ECE/TRANS/XXX

## **GLOBAL REGISTRY**

#### **Global technical regulation No. YYY**

TECHNICAL REQUIREMENTS for *QUIET ROAD TRANSPORT VEHICLES with regard to  
the sound emissions.*

*Diagram C:*

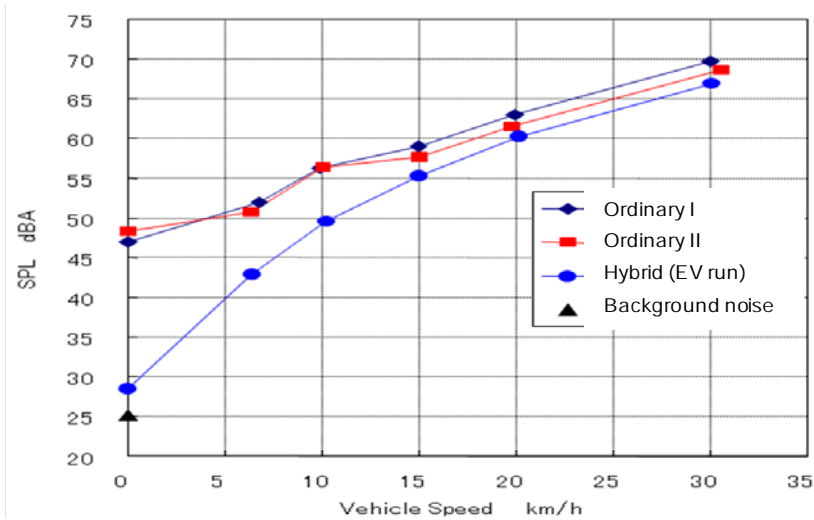
*Japan may wish to update this chart*
